## AGENDA ITEM SUMMARY REPORT

**APPLICATION NO.:** Use Permit 2-23 (UP 2-23), Design Review 3-23 (DR 3-23); [Variance \(VAR 2-24\)](#) Sign Permit 8-23 (SP 8-23)

**PROJECT:** Consideration of Use Permit 2-23, Design Review 3-23, Sign Permit 8-23 and [Variance \(VAR 2-24\)](#) applications requesting to convert an existing commercial building to the following uses: Restaurant with arcade, General Retail, and four Multi-Family Dwelling Units in the inland Central Business District. [The project includes as extensive interior remodel for the conversion of an office building into the aforementioned uses. It also includes the removal of the outdoor teller shelter on the north side of the building, the drive-through structure on the east of the building and installation of a number of windows and doors. The project includes the following associated development: new landscaping, pedestrian walkways, signage, fencing, bicycle parking, dumpster shelter, exterior lighting and mechanical equipment.](#)

**LOCATION:** 228 N. Main Street (APN 018-153-28)

Figure 1. West Elevations - Before (top) and After (bottom)

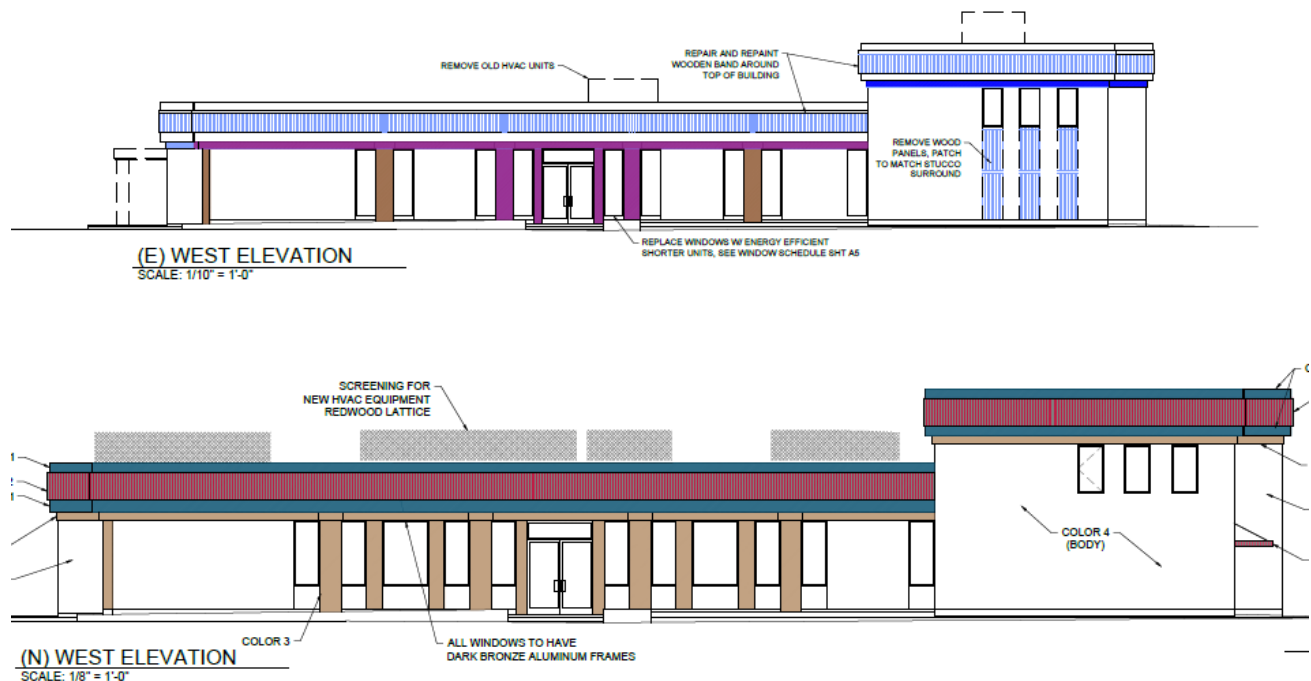
Figures 1 - 4 illustrate the north, south, east, and west building elevations before renovating (top) and after remodeling (bottom) (see also Attachment 3).

<b>Colors, page 17</b> <ul style="list-style-type: none"> <li>Colors used on exterior facades should be <i>harmonious</i> and <i>contrasting compatible colors</i> are encouraged to accentuate details.</li> </ul>	<p>The applicant has proposed a three-color scheme for the remodel of blue-purple, brown, Navajo white, a grey green and sienna (see Attachment 8 for exact colors). The colors may or may not be harmonious, this is a subjective decision for the Planning Commission to make.</p>
